Access Compliance Report

Public Rights-of-Way

(Curb Ramps)

Intersection ID: 11256	Main Street: N_IRWIN_AV	Cross Street: W_5TH_ST	Location: N
ADA ID: ECB11A116BA2	Ramp Type: Perp	Initial Pass/Fail: Fail	Overall Compliance: No
Severity Score: 33.75			
Codes/Mitigation Info/Possible Solution		Field Measurements/Component Compliance

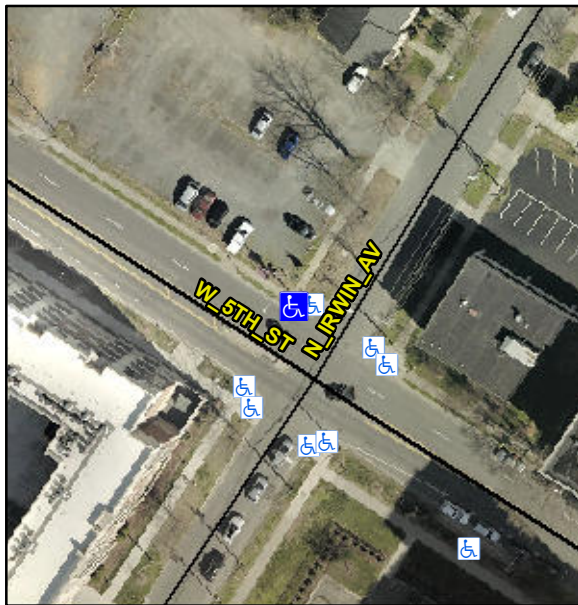
Not Found, R304.5.1, R304.5.3

Compliance	Description	Data	Compliance	Description	Data
N/A	Ramp Length (in)	84.0	Yes	Ramp Slope (%)	6.7
No	Ramp Width (in)	36.0	No	Ramp XSlope (%)	7.7
N/A	Flare Type LT	N/A	N/A	Flare Type RT	N/A
N/A	Flare Slope LT (%)	N/A	N/A	Flare Slope RT (%)	N/A
N/A	Flare Traversable LT?	N/A	N/A	Flare Traversable RT?	N/A
N/A	Landing Length (in)	N/A	N/A	DWS Provided?	N/A
N/A	Landing Width (in)	N/A	N/A	DWS Contrast?	N/A
N/A	Landing Slope (%)	N/A	N/A	DWS Length (in)	N/A
N/A	Landing X Slope (%)	N/A	N/A	DWS Full Width?	N/A
N/A	Landing Curb? (Y/N)	N/A	N/A	DWS Offset (in)	N/A
N/A	Shared Landing?	N/A			
N/A	Gutter Ponding?	N/A	N/A	Gutter Slope (%)	N/A
N/A	Gutter Lip Ht (in)	N/A	N/A	Gutter X Slope (%)	N/A
N/A	Painted X Walk1?	No	N/A	Painted X Walk2?	N/A
	X Walk 1 Direction	To SW		X Walk 2 Direction	N/A
N/A	X Walk 1 Width (in)	N/A	N/A	X Walk 2 Width (in)	N/A
	X Walk 1 Slope (%)	5.2		X Walk 2 Slope (%)	N/A
	X Walk 1 X Slope (%)	4.9		X Walk 2 X Slope (%)	N/A

Remove & Replace Entire Ramp.
